SBN- 609
T.F. B7.1.2

United States Nuclear Regulatory Commission
Washington, D. C. 20555

Subject: Response to 230 Series RAIs; (Geosciences Branch)

PUBLIC SERVICE COMPANY OF NEW HAMPSHIRE SEABROOK STATION - UNITS 1 & 2 FINAL SAFETY ANALYSIS REPORT	HISTORICAL EPICENTRAL DATA AROUND OSSIPEE, NEW HAMPSHIRE	
	FIGURE 230.7-2

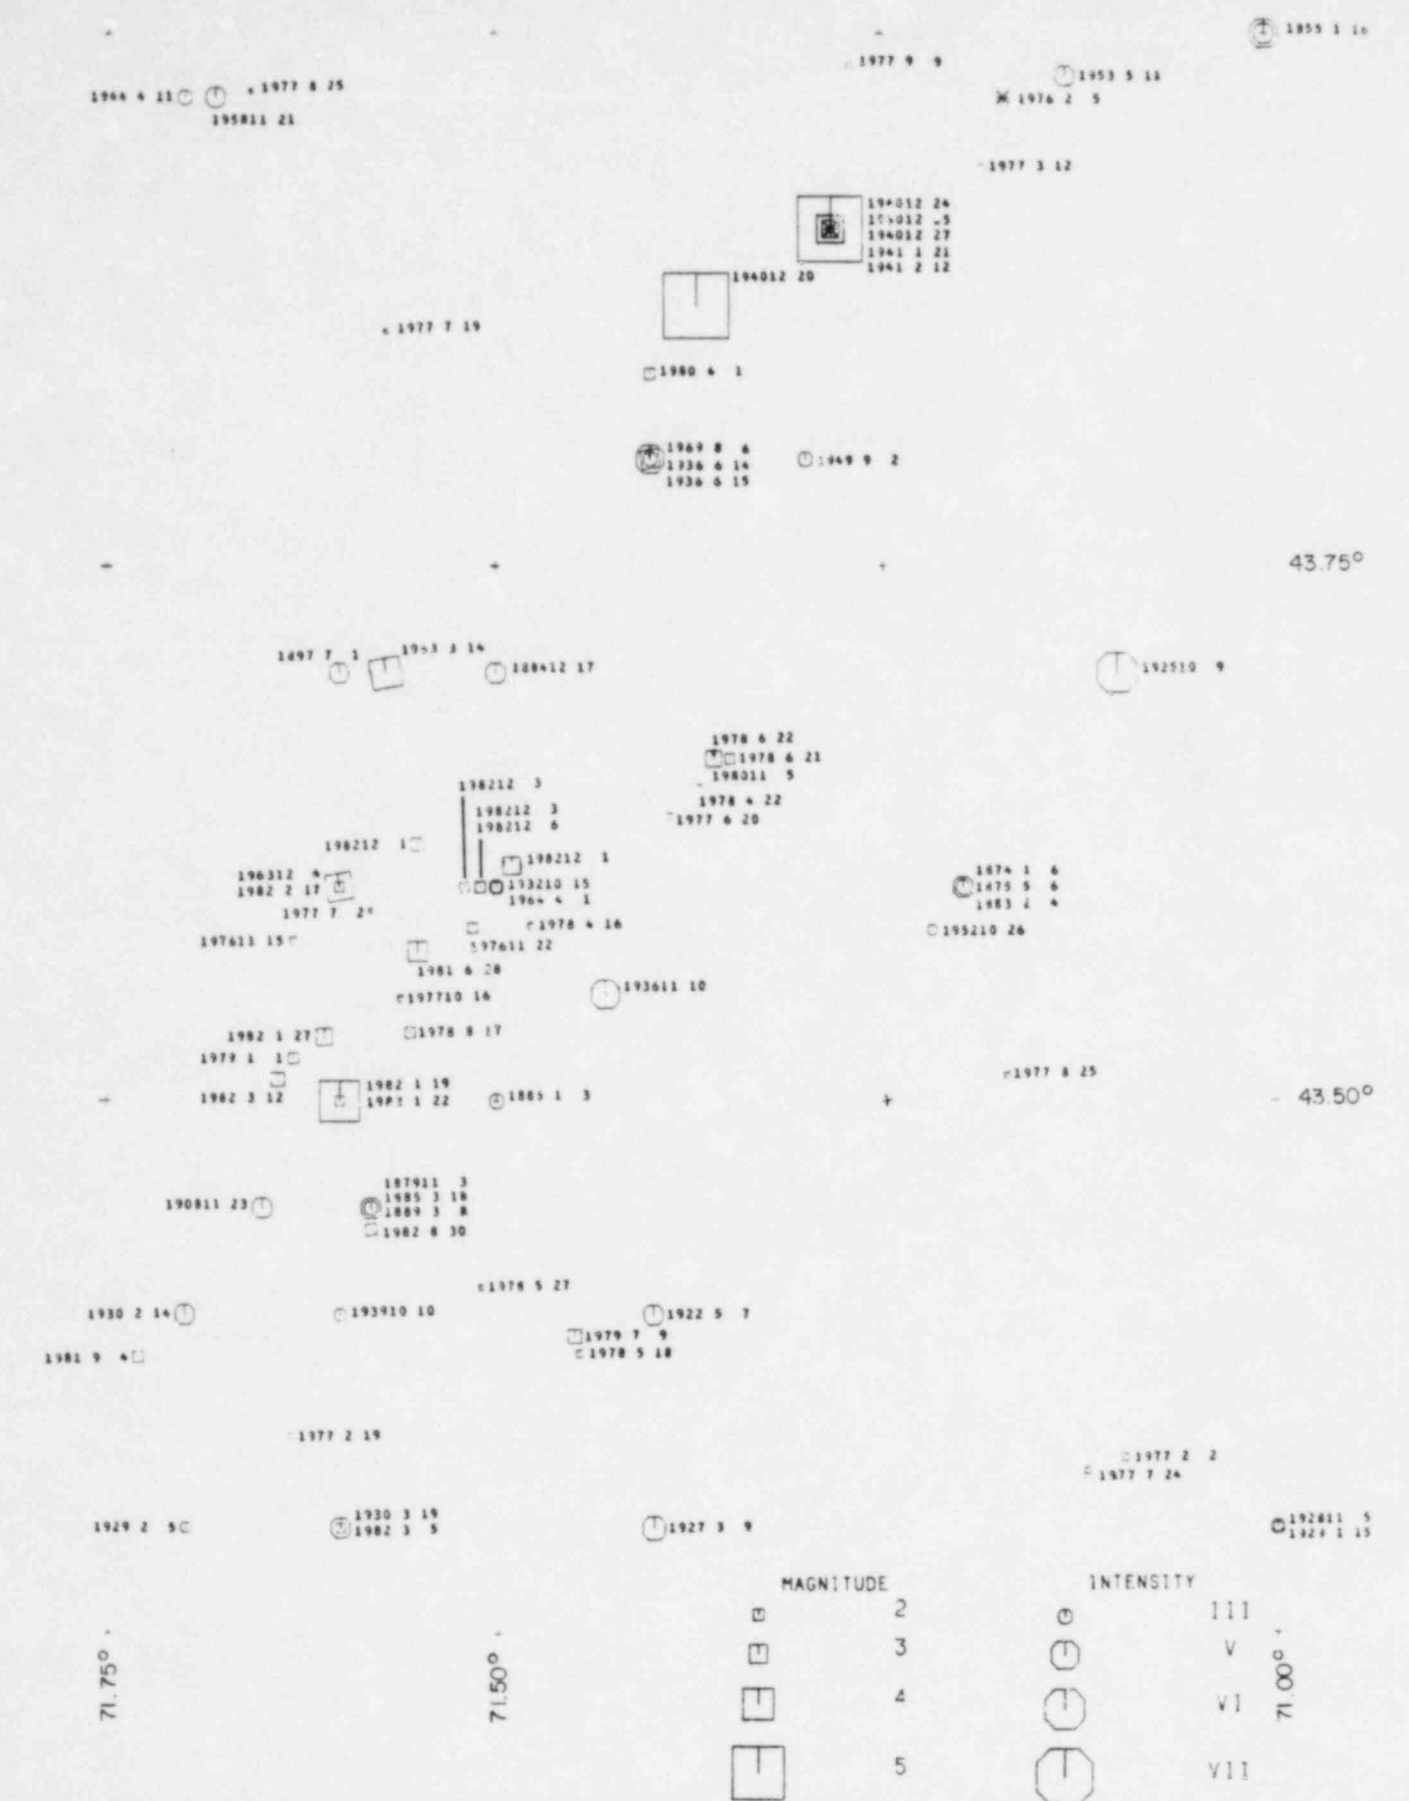
Update your historical record of regional earthquakes up to and including, at least, the time of occurrence of the Franklin, New Hampshire event of January 18, 1982. Discuss the correlation of this and other recent events with geologic structure or tectonic provinces and their significance with respect to the OBE and SSE. Discuss the effect of any strong motion data obtained from the New Hampshire event and other recent events upon empirical strong motion relationships used in determining the OBE and SSE.

The January 19, 1982 (U.T.) event ($m_b = 4.7$) in the central New Hampshire area falls along a pre-existing north-northeast trending alignment of both instrumental and historical seismicity, as shown on Figure 230.7-2. Included within this alignment are the 1940 events ($m_b = 5.5$) which are spatially associated with the Mesozoic Ossipee intrusive complex. This association is fully discussed in the Boston Edison Co. Pilgrim Unit II Docket, (1976) and the Seabrook FSAR (1982). The Franklin event of January 1982 is approximately 41 km southwest of the relocated 1940 events and approximately 35 km southwest of the Ossipee complex.
